REPORT 26-03-R-006

DESIGN OF THE WES CENTRIFUGE

(PHASES 3A & 3B)

FINAL TECHNICAL REPORT

**Figure 1 Proposed operating envelope
for the Acutronic 684-1 centrifuge following the Final Design Review
(after Acutronic France SA)**

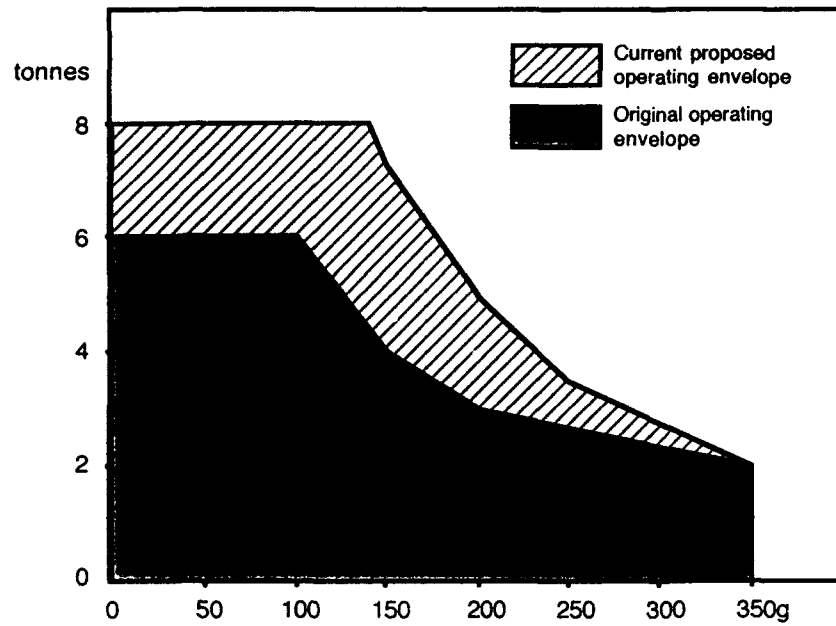
ANS&A recommend that the operating envelope of the centrifuge as designed be revised in the 150 to 350g range to fully benefit from the high load capacity of the swinging platform design. The operating envelope, which at present is limited in the mid-range by the limiting out-of-balance condition, can be pushed outwards without compromising the safety of the facility provided that the user can guarantee the integrity of the package under all failure conditions.

The operating envelope for the centrifuge is determined by a range of factors depending on g level, Figure 1. At one extreme, at high g, the centrifuge performance is limited by motor power. At the low g end, the performance is limited by the counterweight capacity. In the transition between these criteria of maximum payload and maximum g level the envelope is defined by two conditions: the limiting out-of-balance criterion and the platform stress limit. Unlike the peak power or maximum counterweight capability this section of the operating envelope is capable of being exceeded by a careless or irresponsible user and it is therefore important that the definition of this non-linear boundary is well-understood. The following numbers are broadly accurate but are for illustrative purposes only. Actual values will be defined in the Acutronic user manual.

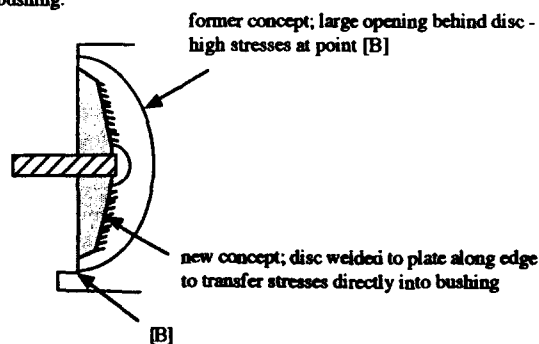
The details of the mesh (for the analysis of the slab) around the pins was discussed. It was explained that rod elements were used with radial spokes [A] connecting to the "bushing". The pin and bushing were considered to be a single unit, incapable of relative movement because the chosen taper of the pin (around 5°) was less than the friction angle of metal on metal (around 5.7°). When loaded it is considered that the pin cannot slide and therefore that modelling as a solid unit is acceptable. However the stiffness of the rod elements (such as [A]) are clearly the key to the rotational stiffness of the pin; this will be adjusted in further analyses to match the stiffness of the pins deduced from the pin analysis itself.

High stresses near [B] (which were a concern from the earlier plots) would be smoothed out by a proposed redesign of the back of the bushing.

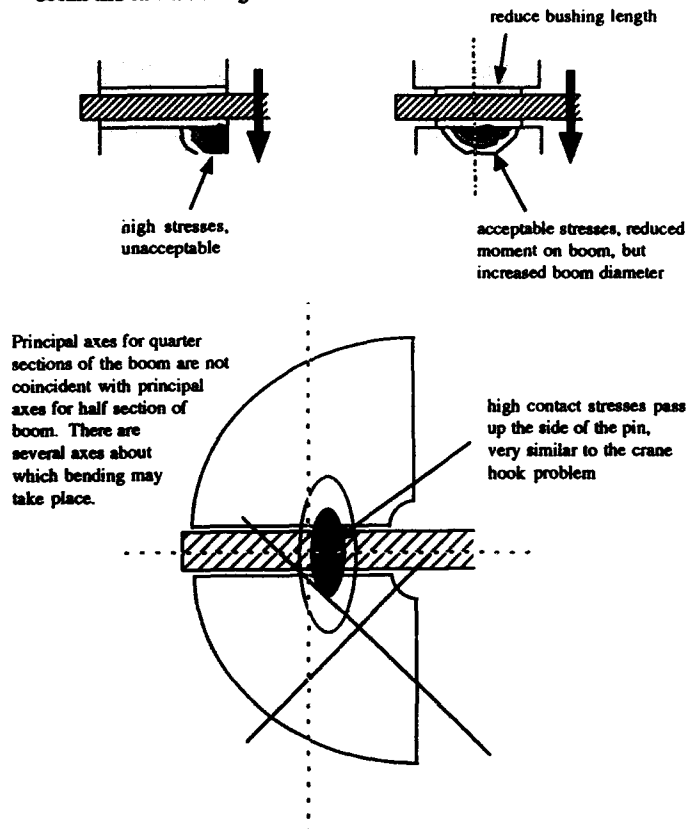
Arrangements for the supporting shroud were discussed. The attachment detail as presently configured is likely to lead to high stresses in the mounting due to compatibility of strain between the main strap and the attachment detail. This will need to be redesigned.

modify and remove metal here to reduce extensional strain
